Development Changes in PD-Phase

DC No. / 开发更改编号: PDECR_0016

Customer project Name/ 客户项目名称:	57cc e-compressor	MCR No. / MCR号:	BM-00095101_003
Affect Product No. / 产品号:		Component No. / 零部件号:	
所有57cc e-compressor成品		F01Z7A008T-01& 见如下:	
Sample type / 样品类型:	☐ A ☐ B ☒ C ☒ FD	Initiator/发起人:	Fan Change (RBCD/EIS4)

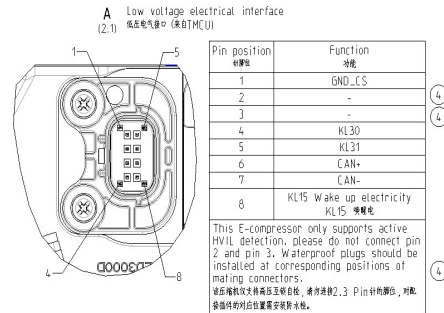
6: TCD中定义冷冻油类型:

7: 目前BOM中992.0 位置预留了datasheet 的位置号

Bom 中TCD 位置号997.9

TCD:F01Z7S0010-01
